Product Change Notification

Change Notification #: 106427 - 00
Change Title: SC5400, PCN 106427-00, Product Design, Class 2, Thermal Sensor Reliability
Date of Publication: June 14, 2006

Wide View:

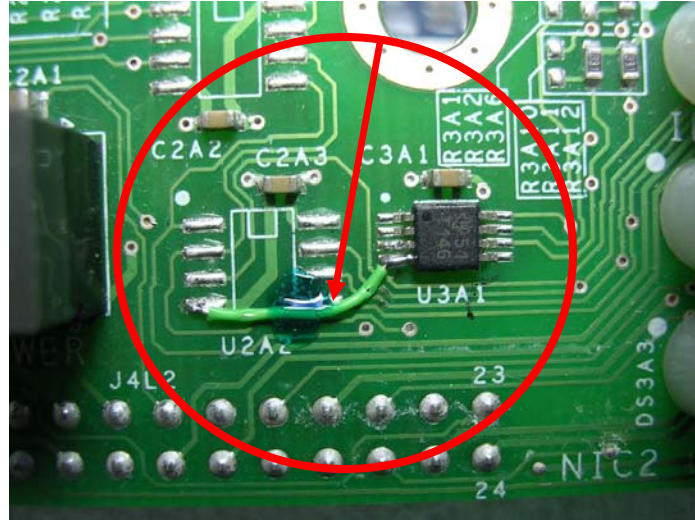
A wire is being added to the front panel board to increase reliability of the front panel thermal sensor. The wire will run between pin4 of U3A1 and GND.
